Access Compliance Report

Public Rights-of-Way

(Curb Ramps)

Intersection ID: 50233	Main Street: ORCHARD_STONE_RN	Cross Street: ARDREY_KELL_RD	Location: SW
ADA ID: 30DABD96F04F	Ramp Type: Perp	Initial Pass/Fail: Fail	Overall Compliance: No
Severity Score: 8.75			
Codes/Mitigation Info/Possible Solution		Field Measurements/Component Compliance

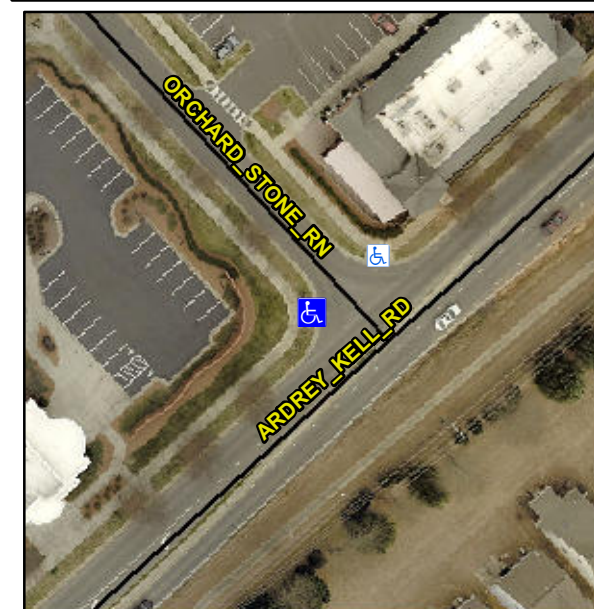
Not Found, R304.5.1

Compliance	Description	Data	Compliance	Description	Data
N/A	Ramp Length (in)	92.0	Yes	Ramp Slope (%)	6.6
No	Ramp Width (in)	46.0	Yes	Ramp XSlope (%)	0.2
N/A	Flare Type LT	N/A	N/A	Flare Type RT	N/A
N/A	Flare Slope LT (%)	N/A	N/A	Flare Slope RT (%)	N/A
N/A	Flare Traversable LT?	N/A	N/A	Flare Traversable RT?	N/A
N/A	Landing Length (in)	N/A	N/A	DWS Provided?	N/A
N/A	Landing Width (in)	N/A	N/A	DWS Contrast?	N/A
N/A	Landing Slope (%)	N/A	N/A	DWS Length (in)	N/A
N/A	Landing X Slope (%)	N/A	N/A	DWS Full Width?	N/A
N/A	Landing Curb? (Y/N)	N/A	N/A	DWS Offset (in)	N/A
N/A	Shared Landing?	N/A			
N/A	Gutter Ponding?	N/A	N/A	Gutter Slope (%)	N/A
N/A	Gutter Lip Ht (in)	N/A	N/A	Gutter X Slope (%)	N/A
N/A	Painted X Walk1?	No	N/A	Painted X Walk2?	N/A
	X Walk 1 Direction	To NE		X Walk 2 Direction	N/A
N/A	X Walk 1 Width (in)	N/A	N/A	X Walk 2 Width (in)	N/A
	X Walk 1 Slope (%)	0.0		X Walk 2 Slope (%)	N/A
	X Walk 1 X Slope (%)	2.0		X Walk 2 X Slope (%)	N/A

Remove & Replace Entire Ramp.
